**Ibex Lighting Project No: 9514**

**PROPOSED SUNFIELD MASTERPLANNED COMMUNITY  
ARDMORE AIRPORT SAFEGURDING – LIGHTING and GLARE**

### **3. Review Proposed Sunfield Development – Ardmore Airport Safeguarding Section 5.5 Lighting and Glare**

FIGURE  
B22156/07  
DRAWN: MKR Checked: BMMV Approved: BHM 04.03.24 Rev 2

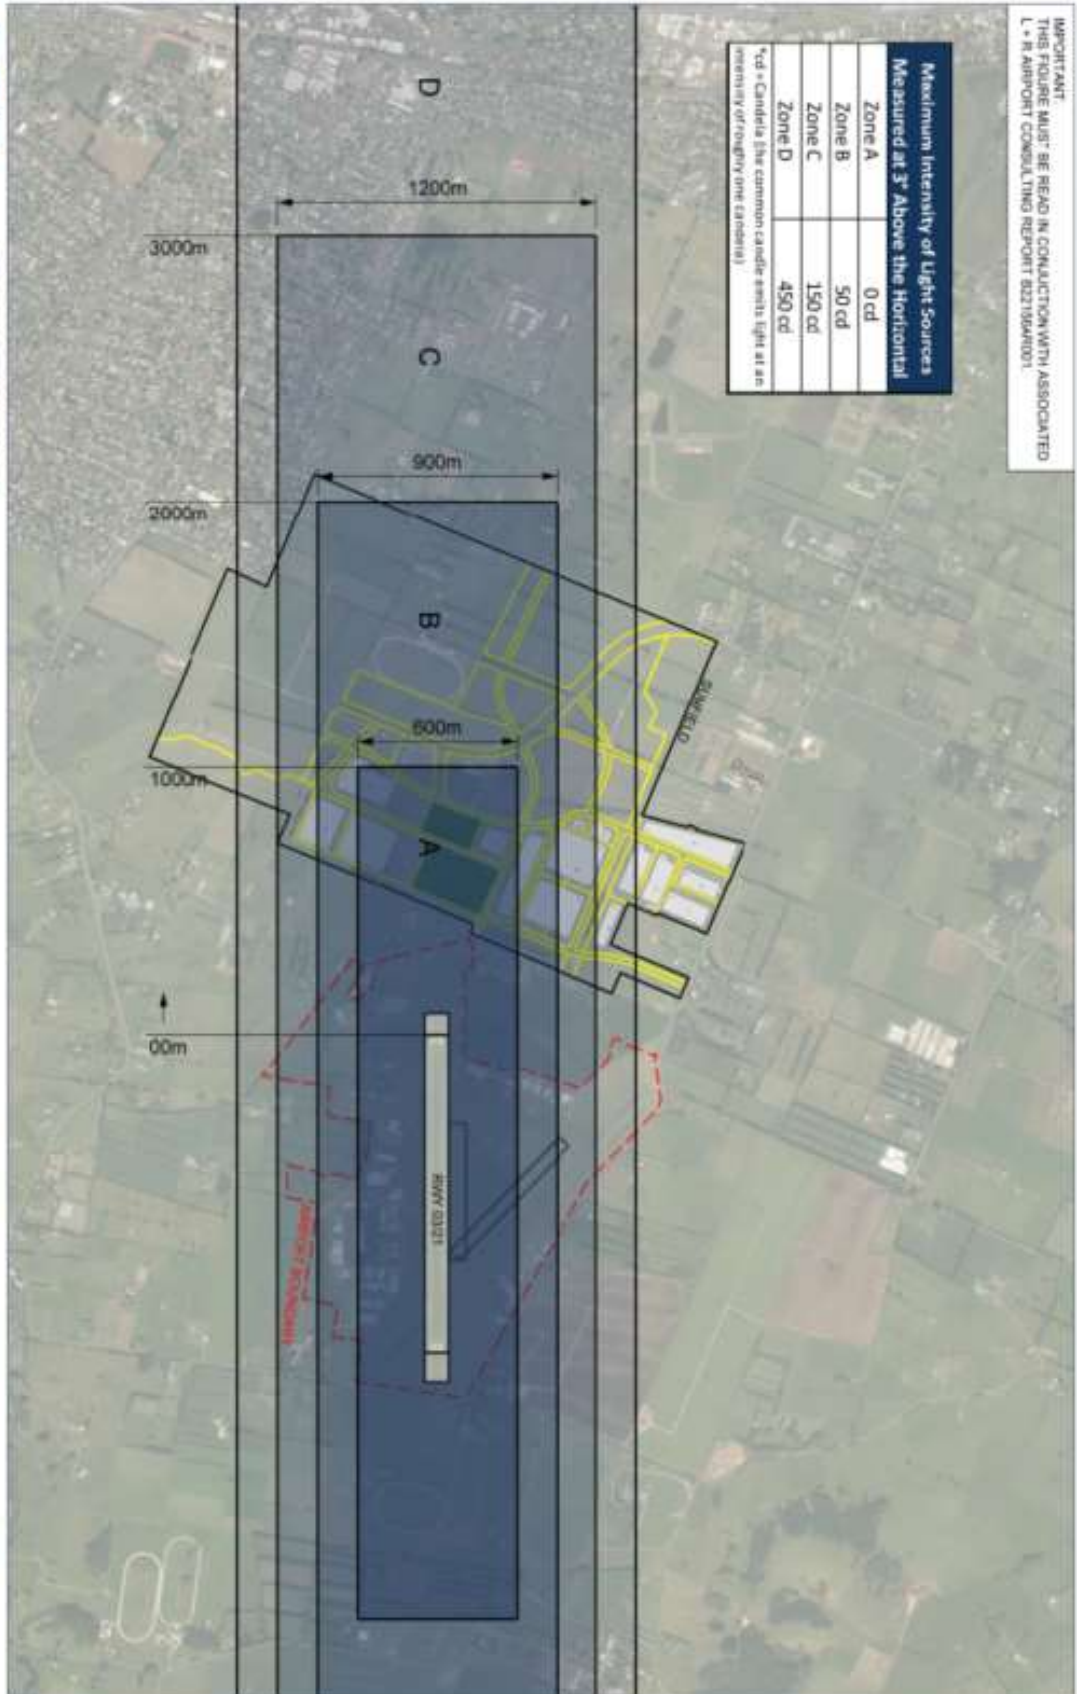
The Lambert & Rehbein Report Figure B22156/07 in Appendix A sets out these control zones relative to the Ardmore Airport runway and identifies that the proposed Sunfield Development impacts all four zones. The plan has been extracted from the report and inserted below for ease of reference.

Section 5.5.3 also states that the lighting designer should ensure that all lighting within the development, both public i.e. street lighting and private (associated with the development buildings) will meet this requirement.
